APPENDIX N

DEPARTMENT OF TRANSPORTATION SECTION 4(f)

The Federal Aviation Administration (FAA) is providing additional information to the Ohio Historic Preservation Office (OHPO) in response to your letter dated July 14, 2008. The letter was from the OHPO in response to the Draft Environmental Impact Statement (DEIS) and Section 106 coordination for the proposed airport development at the Port Columbus International Airport.

1. No. **FRA-09787-12**

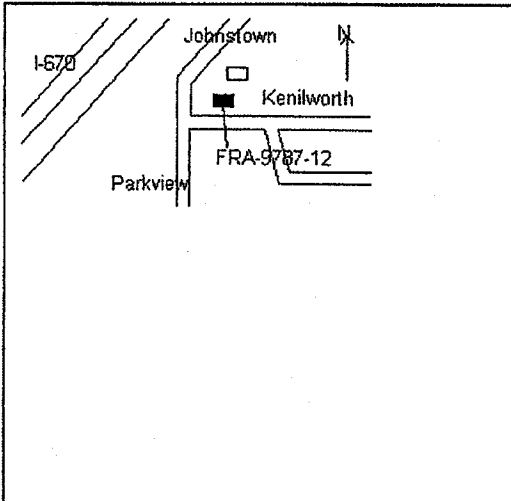
OHPO Comment: It is requested that Ohio Historic Inventory forms and more detailed eligibility evaluations should be prepared for properties shown in photo 4, photo 5, and photo 6.

FAA Response: See the attachment, "OHI Forms/Photos 4, 5, and 6". The FAA is providing the Ohio Historic Inventory forms for Photo 4, Photo 5, and Photo 6. Attached to each Ohio Historic Inventory form is additional information regarding each subject property.

Plate 1. TAT Hangar in 1929.

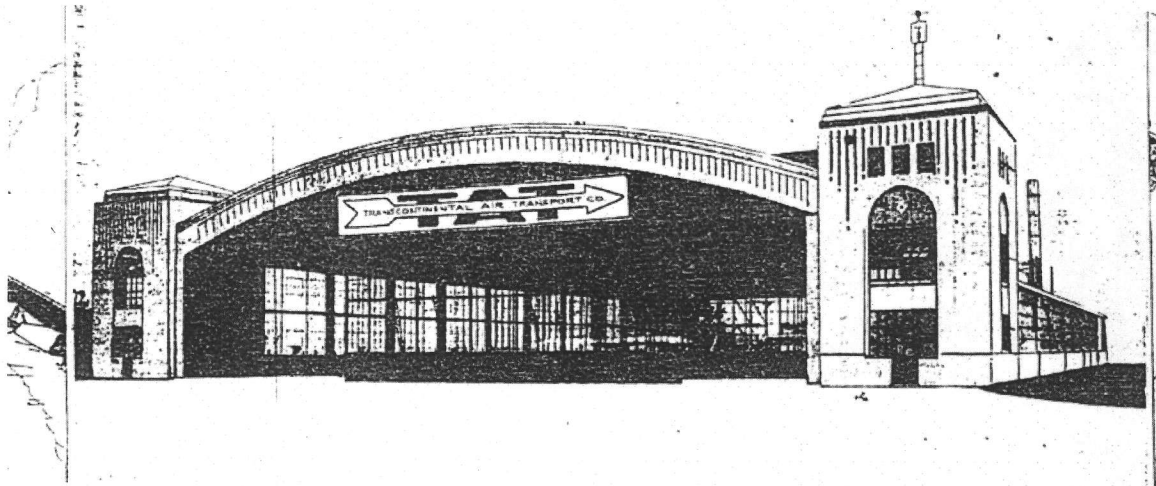
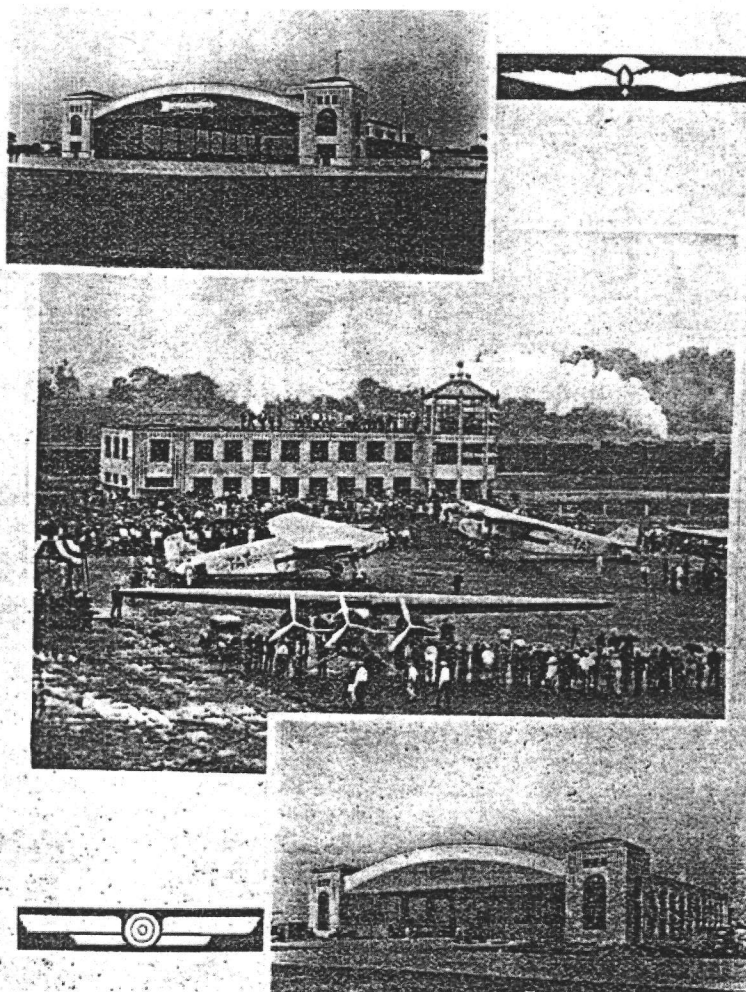
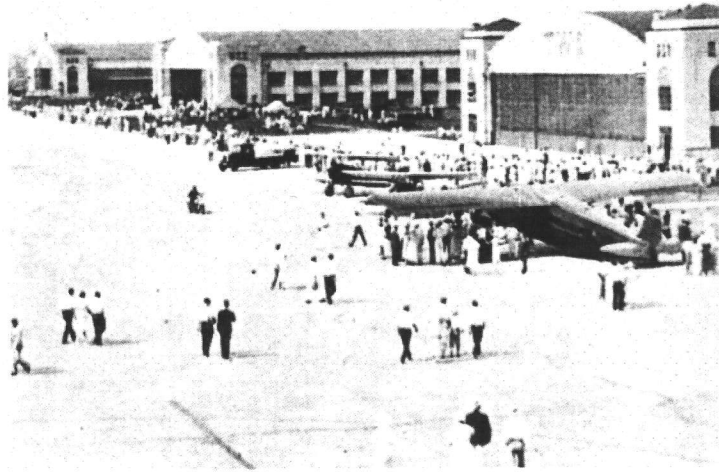
OHPO Comment: It is requested that additional photos and analysis in support of the negative eligibility determination for the Nationwide Hangar, since it appears to date to the same early airport development period as the TAT Hangar. The supporting materials do not provide sufficient information to clearly show the diminished integrity described in the survey's analysis.

FAA Response: See the attachment, "Nationwide Hangar". The FAA is providing additional information on the negative eligibility determination for the Nationwide Hangar.
